BMW Motorrad USA

Service Information Bulletin

Subject: Gearbox shift lever

Models: S 1000 RR (K46/12)

Illustration: Gearbox shift lever

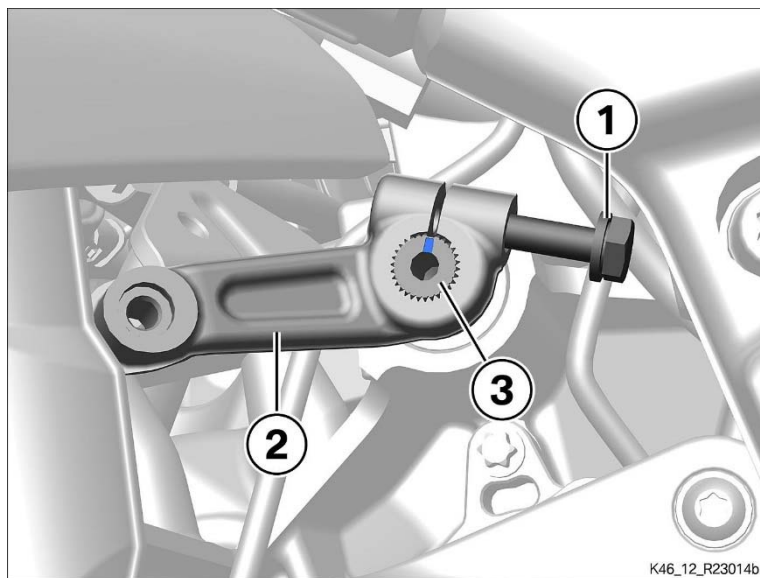
Details: BMW Motorrad has ascertained that in some cases gearbox shift lever (2) can work loose from gearshift shaft (3). As the distance covered by the motorcycle increases in the course of usage (frequency of gearshifts) the play between gearshift shaft and gearbox shift lever can increase to the extent that the gearbox shift lever works loose.

Service Solution: The vehicles in question will have to be checked and the gearbox shift lever replaced either before the new vehicles are handed over to customers or when the vehicles are brought in to the workshop.

The specified tightening torque of screw with washer (1) has been increased from 8 Nm to **10 Nm**. The data on the RSD (Repair and Service Data BMW Motorrad) DVD will be updated in the next edition (09/2015).
